Product Change Notification

Change Notification #: 114622 - 01
Change Title: Intel® Server System R2312GZ4GC4
PCN 114622 - 01, Product Design, Air duct
improvement,
**Reason for Revision: Pre/Post TA Change
value was missing a leading digit in the
Revision Number**
Date of Publication: June 1, 2016, 2016

New air duct lock hook

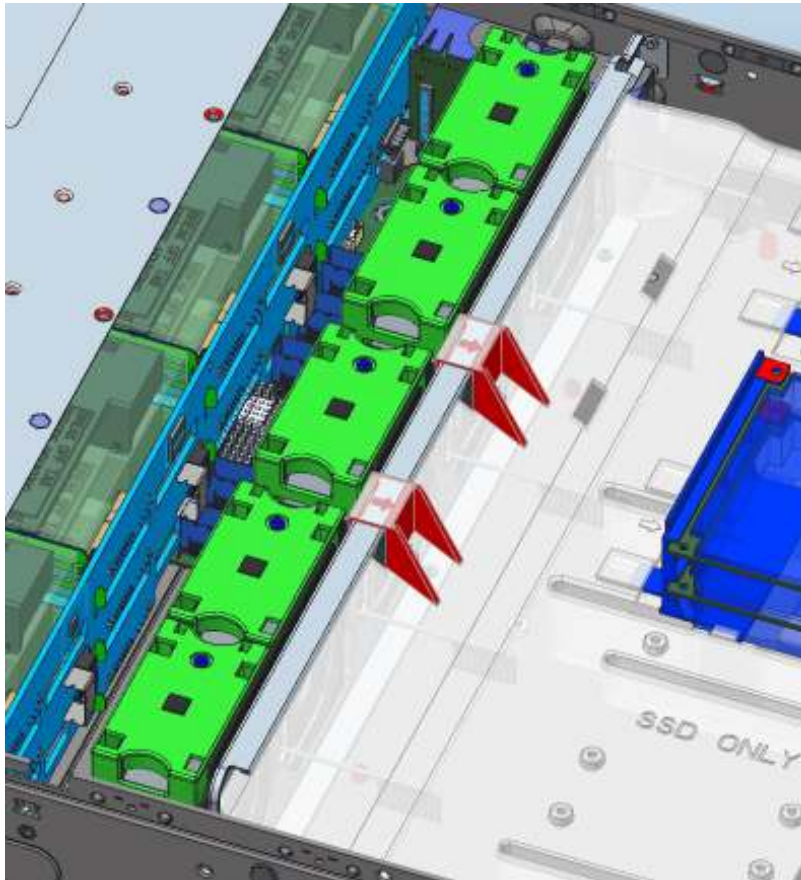
1. Change air duct lock feature: Change air duct lock hook so the air duct will hook over the FAN bulkhead. This will improve the fixing of air duct during transportation.
